WCAP-17236-NP, Rev. 0
Project Number 694

Subject: Pressurized Water Reactor Owners Group
Responses to the NRC Request for Additional Information (RAI) on PWR Owners Group (PWROG) WCAP-17236-NP, Revision 0 "Risk Informed Extension of the Reactor Vessel Nozzle Inservice Inspection Interval" (TAC NO. ME4878) PA-MSC-0440

Subject: Response to NRC Request for Additional Information and Mark-Up Pages for WCAP-17236-NP, Revision 0, "Risk-Informed Extension of the Reactor Vessel Nozzle Inservice Inspection Interval"

Figure DCI-RAI-2-2 – Flow Chart for Piping Weld Failure Modes (from Reference 4)

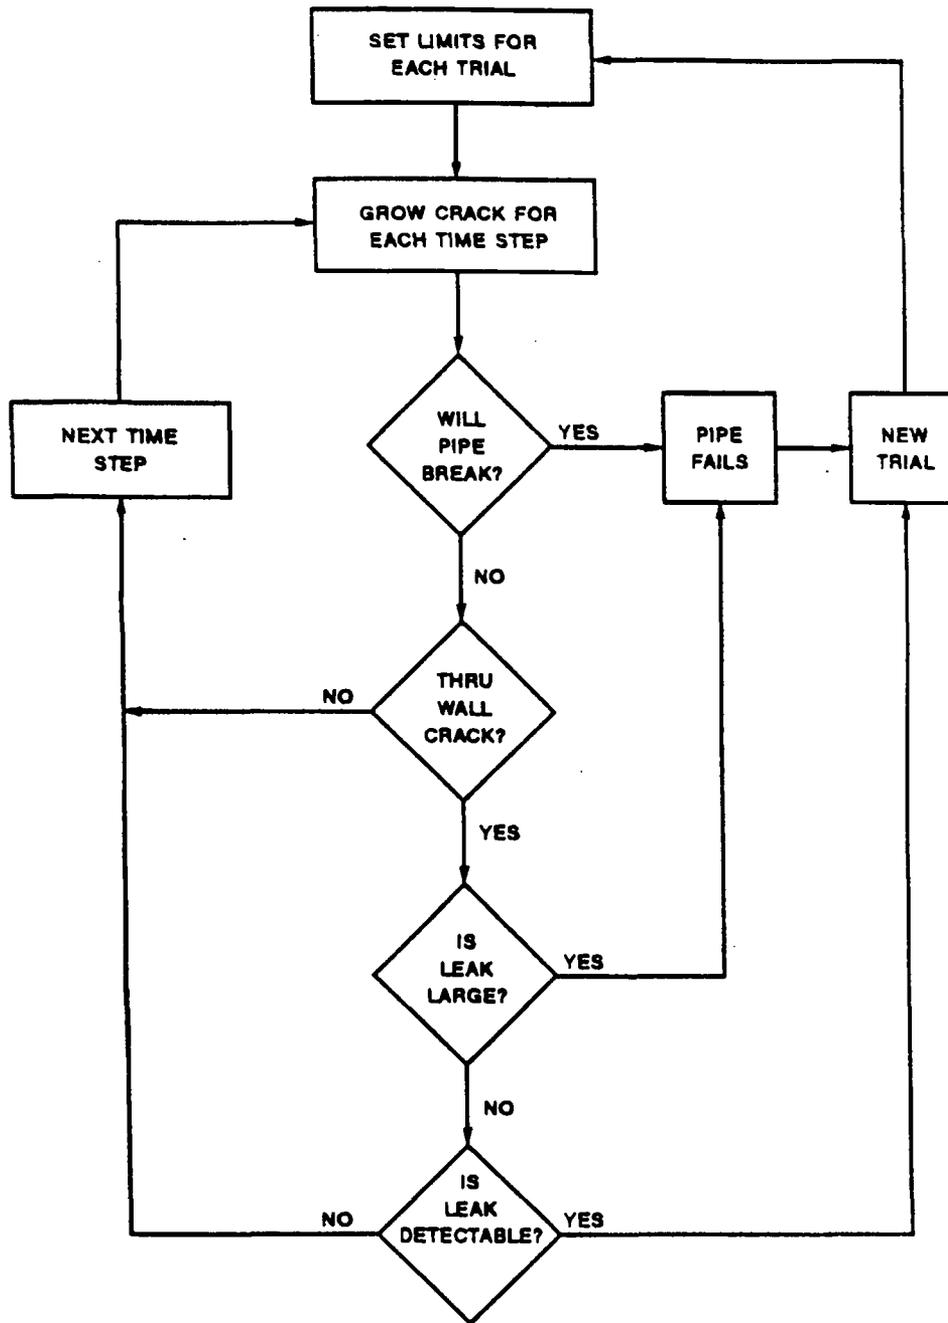
DCI-RAI-2 *Section 2.4.1 of TR WCAP-17236 mentions that "the calculations are performed using the change in failure frequencies with credit for leak detection." Provide a summary of the PFM analysis methodology used in TR WCAP-17236, including:*

The PFM methodology used to calculate the change in failure frequencies with credit for leak detection is summarized as follows:

4. To calculate the failure probabilities for the failure modes of specified leak rates, such as a small-break loss-of-coolant accident (LOCA), a medium or large-break LOCA or the effects of leak detection on a full break due to ductile rupture, the pre-processor program CLVSQ is used. CLVSQ stands for crack length versus the leak flow Q, and typical calculated results are shown in Figure DCI-RAI-2-1 (Figure 2-4 in the SRRA Supplement, Reference 4). The crack flow rate, dQ/dt, in gallons per minute (GPM) is calculated in CLVSQ using the equation:

$$dQ/dt = 0.06 P A / w^{0.5}$$

Where P is pressure in psi, A is the crack opening area in square inches, and w is the weld wall thickness in inches. This equation is based upon calculated results from the pc-PRAISE Code (NUREG/CR-5864, LLNL, 1992) with an improved leak leak-rate model similar to that in the PICEP Computer Code contained in the 1984 EPRI Report, NP-3596-SR. The constant value of 0.06 in the equation was derived for the improved pc-PRAISE results for five different sets of pipe sizes and operating conditions. However, the base case was for large-diameter piping welds at PWR reactor coolant system (RCS) operating conditions that would be directly applicable to the RV nozzle-to-pipe welds. The CLVSQ program also requires weld material properties for calculating the crack opening area as a function of crack length for the applied pressure, deadweight and thermal stresses per the elastic-plastic analysis methods contained in the 1984 EPRI Report NP-3607. Specifically, the crack opening displacement is calculated by numerically integrating the plastic stress intensity factor (J) along the length of the crack. The elastic-plastic weld material properties that are used in the CLVSQ program for type A-106B carbon and types 304 or 316 stainless steel, respectively, are the same as the default input values to the improved pc-PRAISE Code. Finally, the crack leak rates for small, medium, or large loss-of-coolant accidents (LOCA) are 100 GPM, 1,500 GPM and 5,000 GPM, respectively, per Sandia National Laboratory Report NUREG/CR-4550, Revision 1, Volume 1, 1990. A minimum detectable leak rate of 1 GPM is used based upon PWR plant Technical specifications for unidentified leakage.

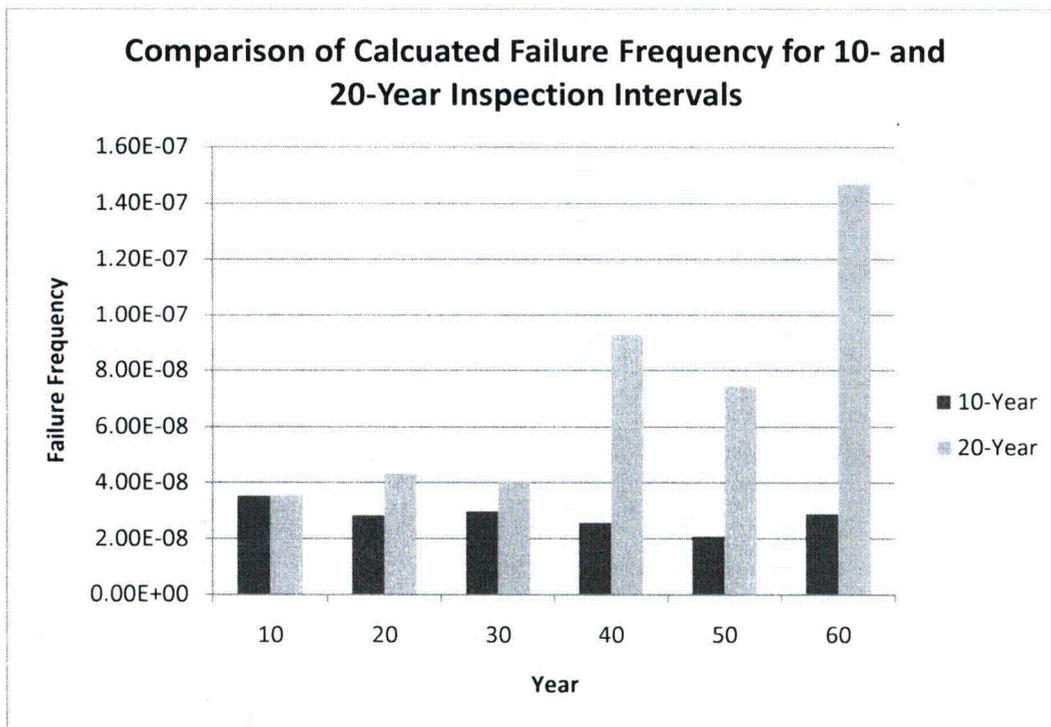
DCI-RAI-3 *Section 3.2.3 of TR WCAP-17236 states, “[t]he SRRA [Structural Reliability and Risk Assessment] Code was developed for estimating piping failure probabilities to be used in relative risk-ranking of piping segments....” List and discuss any significant part of the SRRA Code which was not needed in generating results supporting prior applications, but are needed now to generate PFM results to support the current application for RV nozzle-to-pipe welds.*

There were no parts of the SRRA Code used in generating PFM results for this application that were not needed in generating PFM results for the prior risk-ranking application. The same version of the SRRA Code that was used in previous applications for risk-informed ISI of piping welds was also used to generate the PFM results to support the current application for RV nozzle-to-pipe welds.
